[Docket No. FAA-2007-28661; Directorate Identifier 2007-NM-013-AD]

Airworthiness Directives; The Boeing Company Model 737-600, -700, -700C, -800, and -900 Series Airplanes

ACTION: Supplemental notice of proposed rulemaking (NPRM); reopening of comment period.

Figure 1

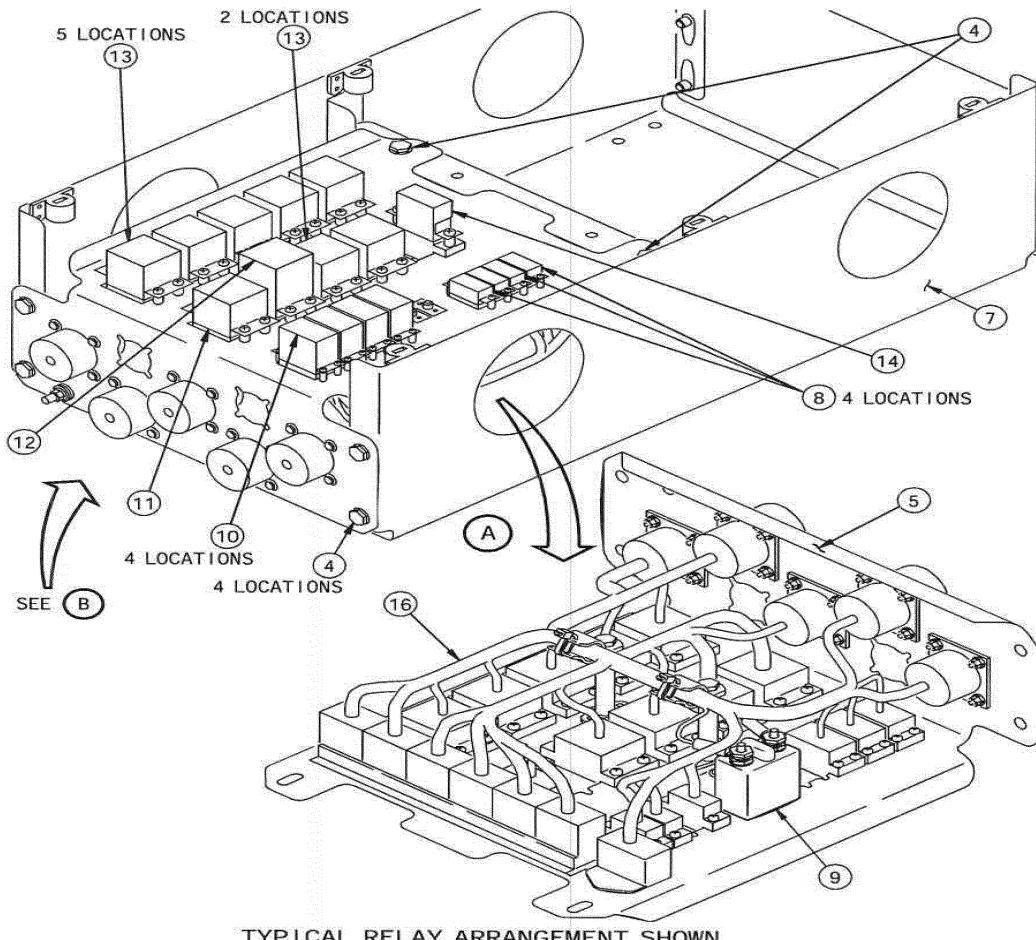
- Sheet 2 of 4 of Figure 11 of Boeing Alert Service Bulletin 737–28A1206, Revision 2, dated May 21, 2009, was inadvertently replaced with Sheet 2 of 4 of Figure 11 from Boeing Alert Service Bulletin 737–28A1206, dated January 11, 2006. That figure was corrected in Boeing Alert Service Bulletin 737–28A1206, Revision 1, dated January 30,

2008, and did not need to be changed in Boeing Alert Service Bulletin 737–28A1206, Revision 2, dated May 21, 2009. We have added Figure 1 in this supplemental NPRM to provide the correct Sheet 2 of 4 of Figure 11.
